SERVICE BULLETIN

PORTABLE OXYGEN CYLINDER ASSEMBLIES - P/N 10014024 – SLING STRAP REPLACES P/N 10013592 – SLING STRAP

SUMMARY

Amendment Label
Figure 1

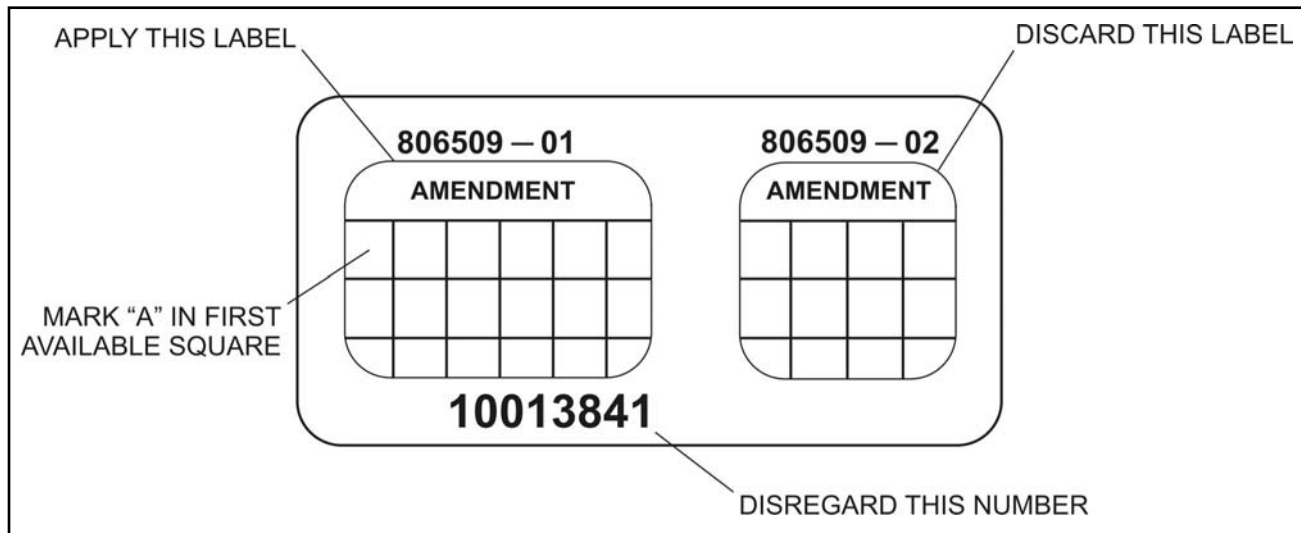
- (1) If not already in place, apply Amendment Label P/N 806509-01 (see Figure 1) to the cylinder only (500, IPL Figs. 1A, 1B, 1C, CMM 35-35-52). Discard Amendment Label P/N 806509-02 (see Figure 1).
- (2) Mark the letter A in the first available square provided on the amendment block on the Amendment Label P/N 806509-01 on the cylinder only (500, IPL Figs. 1A, 1B, 1C, CMM 35-35-52).
